Roland Lebrun

Brisbane Baylands Draft EIR
January 19 2014

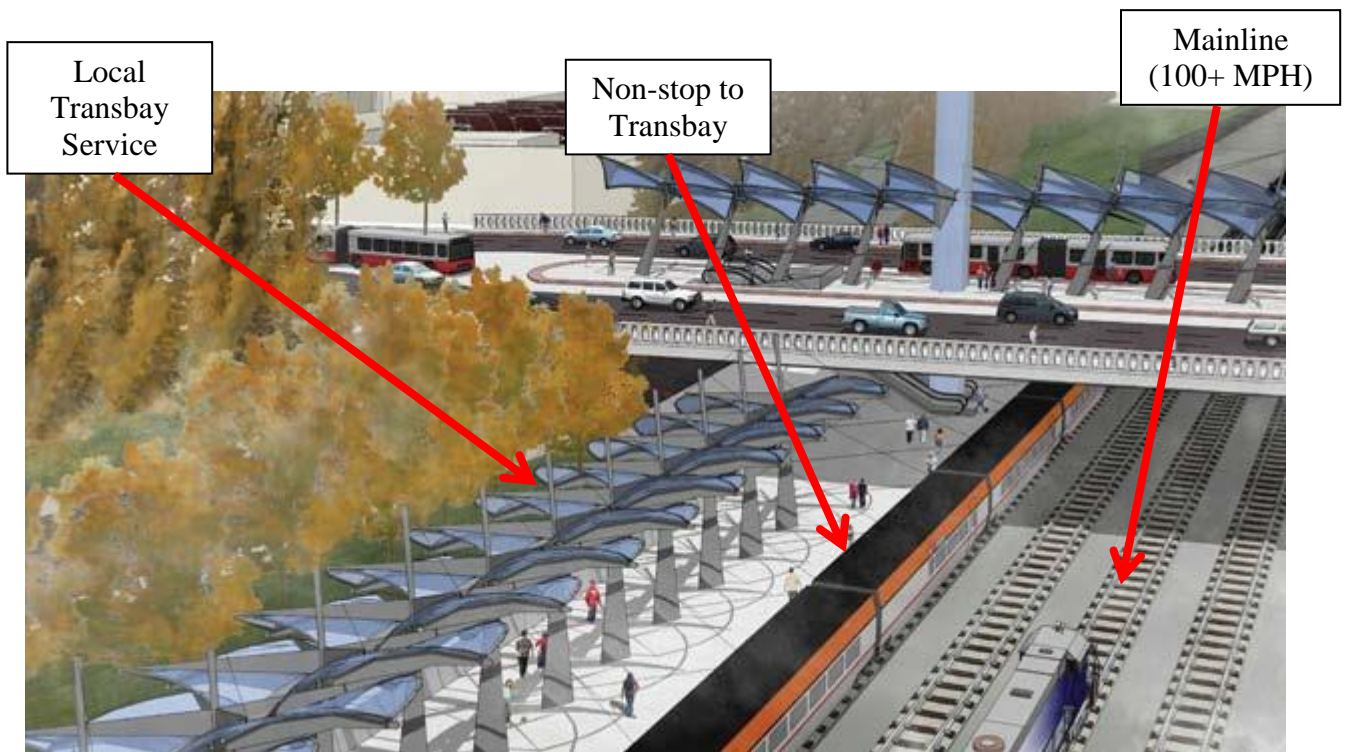
It is in this context that the DEIR should consider a new rail alignment capable of supporting speeds in excess of 100 MPH along the proposed future 5th Street.

The relocation of the tracks and the Bayshore station to the 5th Street alignment would also significantly enhance transfers between Caltrain and the proposed Muni T-Third light rail station on 5th Street.

The relocated Bayshore station would have two additional tracks to facilitate cross-platform transfers between Baby Bullets (5-minute non-stop to Transbay) and locals stopping at Oakdale, 22nd Street, Mission Bay and the Transbay Terminal. The additional station and turnaround tracks would support a capacity of 12 trains/hour between Brisbane and Transbay, 10-20 years ahead of the rest of the Peninsula (Policy 6-12).

Platform lengths.

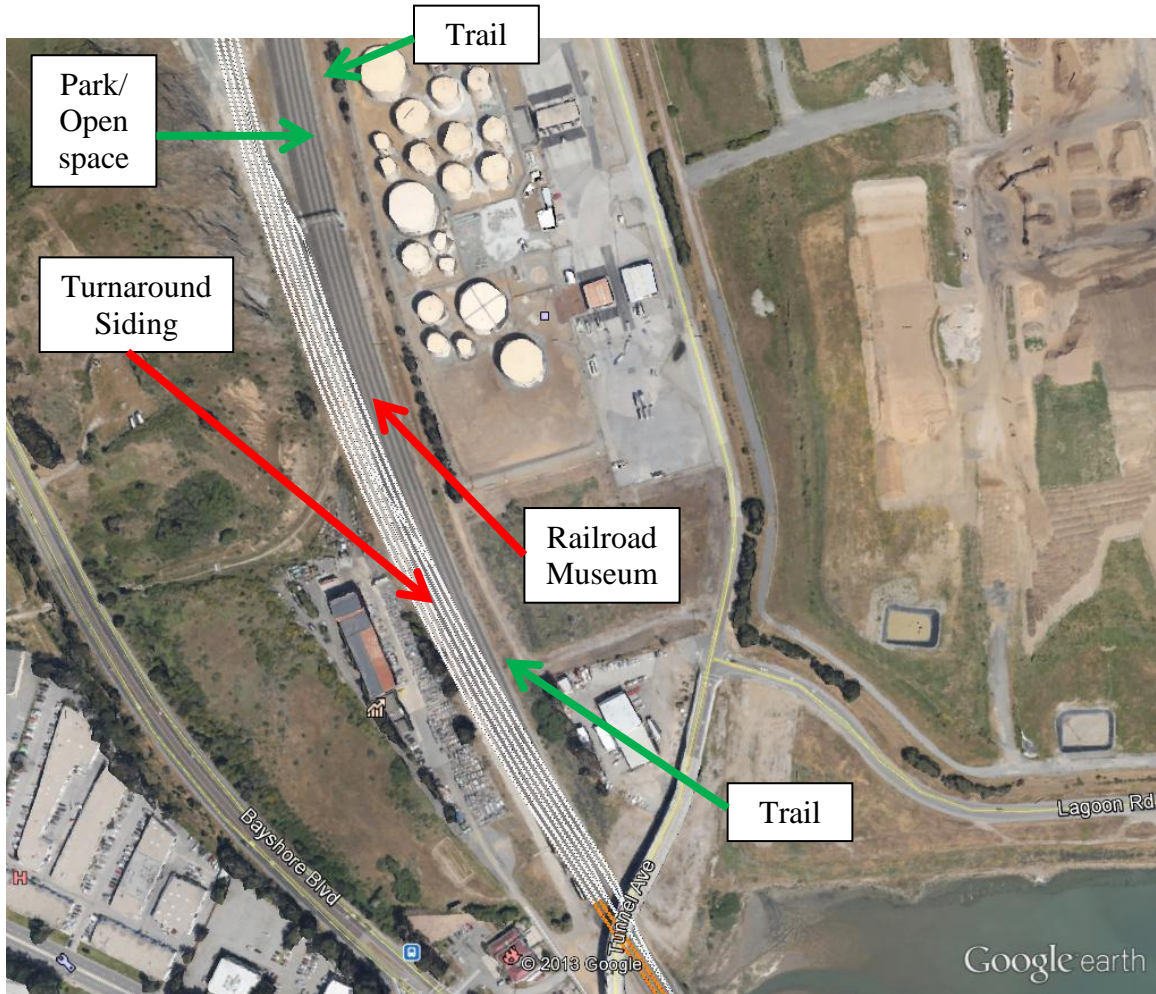
Please refer to "Platform Dimensions" on page 13 of Chapter 3 of the Caltrain Engineering Standards: <http://www.caltrain.com/assets/engineering/engineering-standards-2/criteria/CHAPTER3.pdf> : *"The standard platform length shall be 700 feet to accommodate a six (6) car train consist. Platform design shall consider or not preclude a possible expansion of platform length to 1000 feet"*

The DEIR should consider this 1,000-foot requirement because it would enable a Bayshore Caltrain station entrance at Beatty Avenue which is within walking distance of the Schlage Lock development. The DEIR should also consider extending the platforms south of Geneva Avenue to match Transbay's 1,330-foot platform lengths for two reasons: support for double-length Caltrain consists capable of transporting 2,000 passengers to/from special events in downtown San Francisco and/or Brisbane and the ability to disembark and turn around full-length HSR trains in case of an emergency between Brisbane and the Transbay terminal.
